FT4869 Surge tank cover Chafing on Components (MQR 7621-1762)		
Technical writer name / nom rédacteur technique:	Luc Carignan	Manual/manuel, section: 1

MQR 7621-1762 : Service Solution (Shim)

Surge tank cover Chafing Components – Interferences & Solutions

Revision 05 (Bill of material and SRT added)

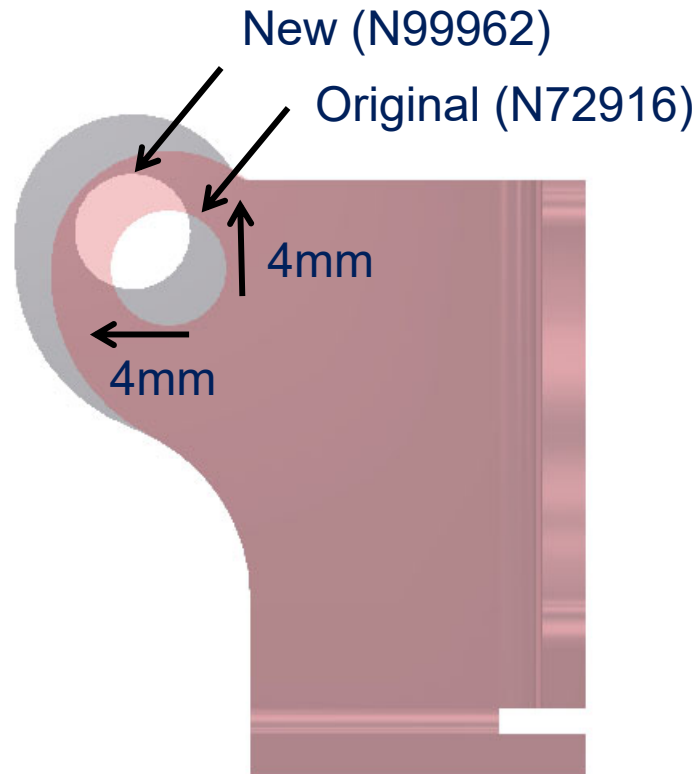
a) Replace original brackets (N72916-1 / -2) with new ones (N99962-1 & -2)

New brackets will relocate the Canopy attaching hole by 4mm upwards & rearwards.

b) Installation Instructions: SIGH GLASS contact

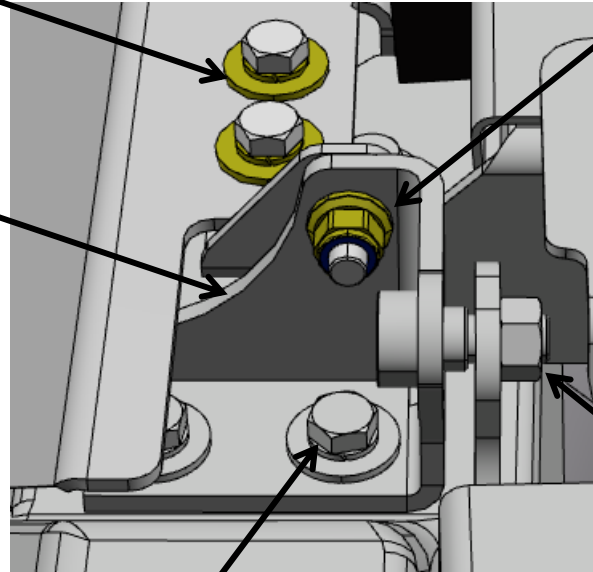
Retain original Hardware for access,
Replace bracket then Torque 27.2 ± 2 Nm +
Loctite 242 (on threads)

Replace original bracket
N72916 with N99962

Retain original screw N31413
Retain original flat washer N29011
Discard original Lock Nut N43233
Torque 27.2 ± 2 Nm
Add Torque seal

Discard original screw N71434
Discard original Nut N21454
Torque 27.2 ± 2 Nm + Loctite 242
(on threads)
Add Torque seal

Retain original screw N28668
Retain original flat washer N28219
Discard original Lock Washer N28220
Torque 27.2 ± 2 Nm + Loctite 242 (on threads)
Add Torque seal

4) Installation Instructions: Without SIGH GLASS contact

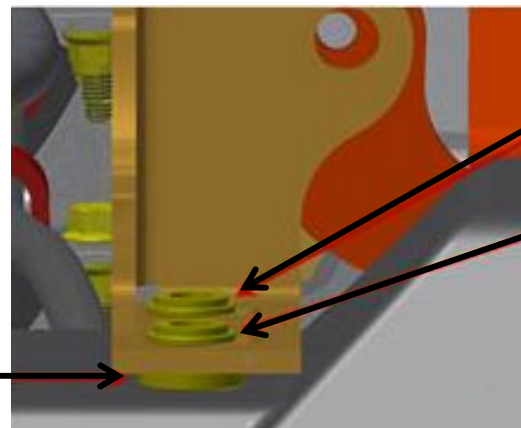
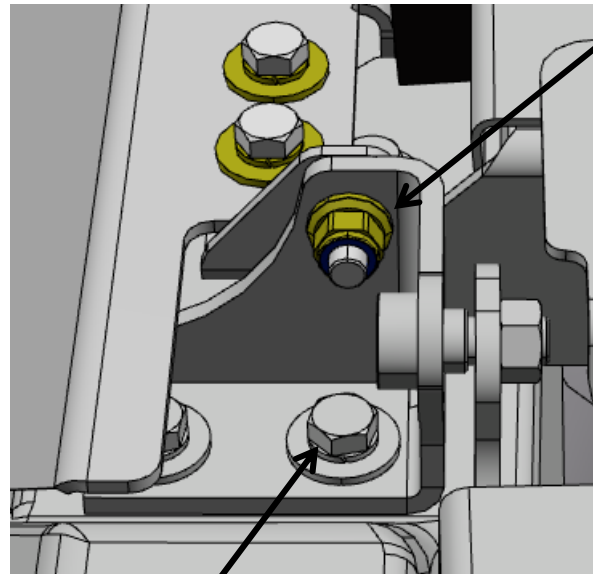
Retain original Hardware
for access,
Shim bracket then Torque
 $27.2 \pm 2 \text{ Nm}$ + Loctite 242
(on threads)

Retain original screw
N28668

Discard original Lock Washer N28220

Retain original flat washer N28219

Original Installation

Add new Washer N30731
4MM thk (Shim)

New Lock Washer N28220

Original flat washer N28219

New proposed installation

5) Validation : With or Without sign glass contact

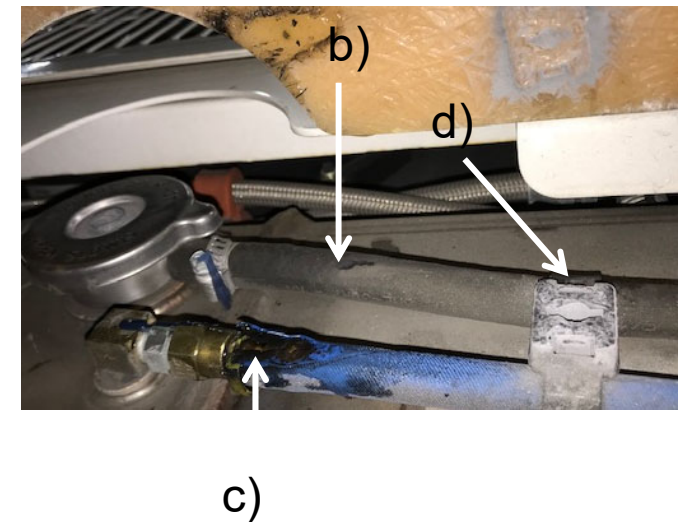
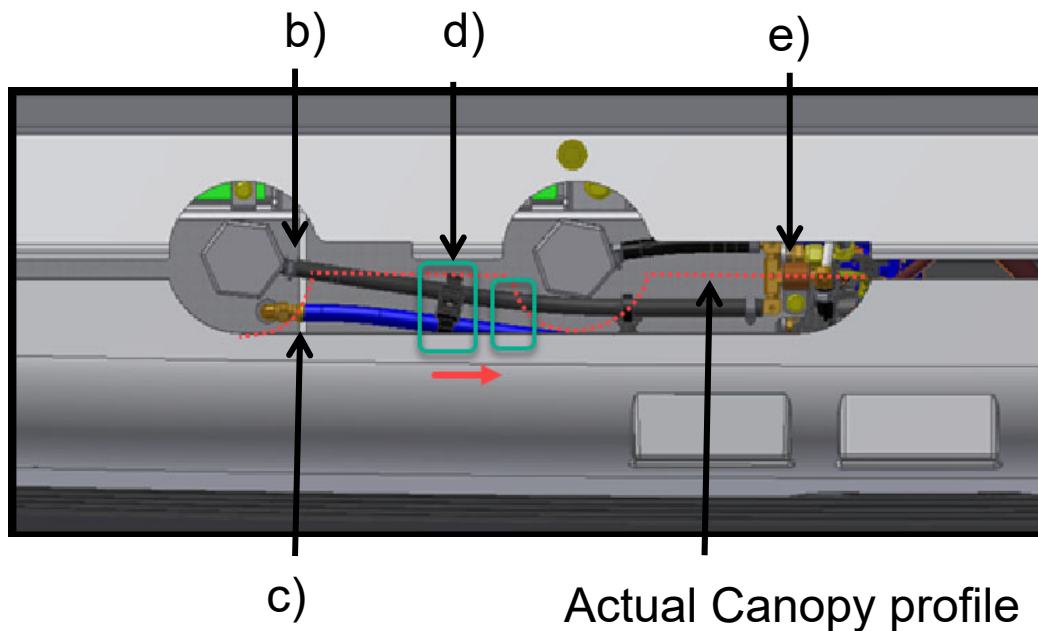
Gain of 4mm to avoid contact of the following components;

- b) Rubber Tube Chafing on Canopy
- c) Fitting and Rubber Tube Chafing on Canopy
- d) Tyton Chafing on Canopy (relocate if required, as shown)
- e) P-Clamp Chafing on Canopy
